CS Memorandum No. 1461

Subject: Configuration Management Board Meeting No. 127

CMB Meeting Minutes #127

SUBJECT: Configuration Management Board Meeting # 127 – Rev. No. 0

NORTH HEADWALL
JET GROUT (PILE SUPPORT) LAYOUT

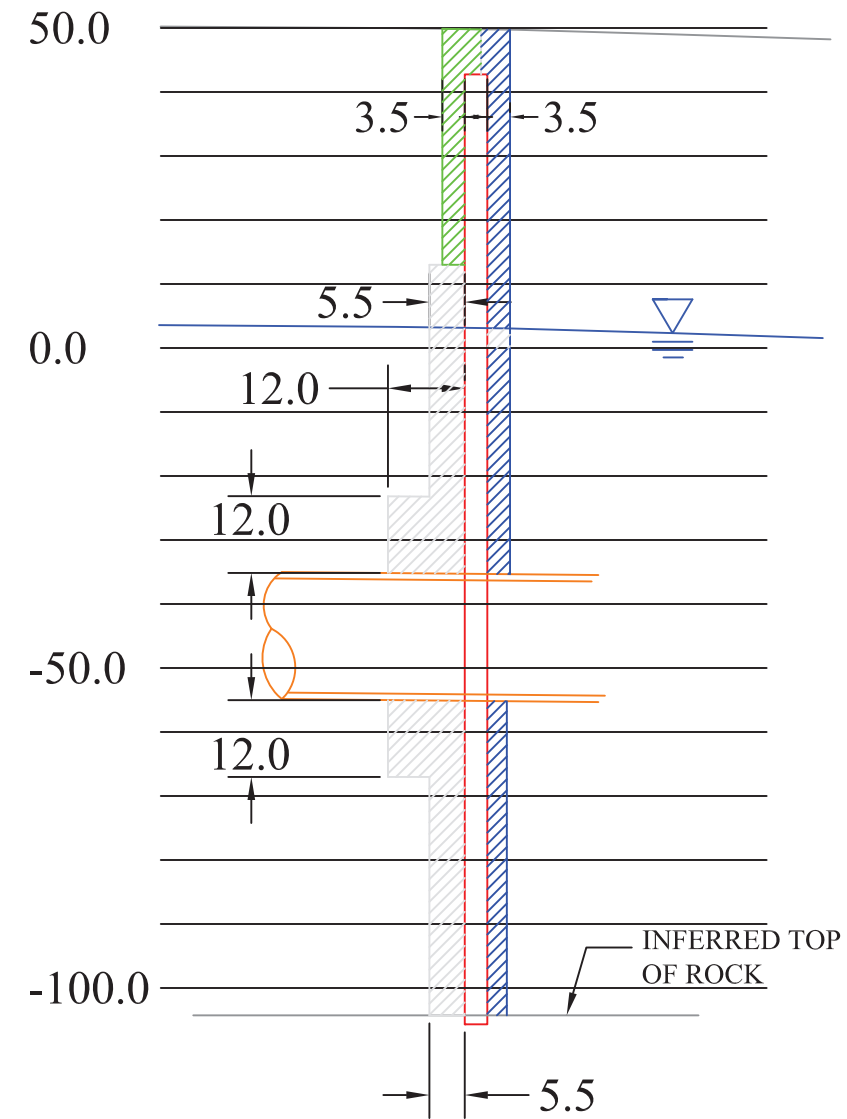
1. *Please provide a revised layout of the jet grout columns, showing minimum and maximum extents relative to secant and tangent piles.*

Refer to Appendix II of the UMS North Headwall Workplan for the revised layout of the jet grout columns.
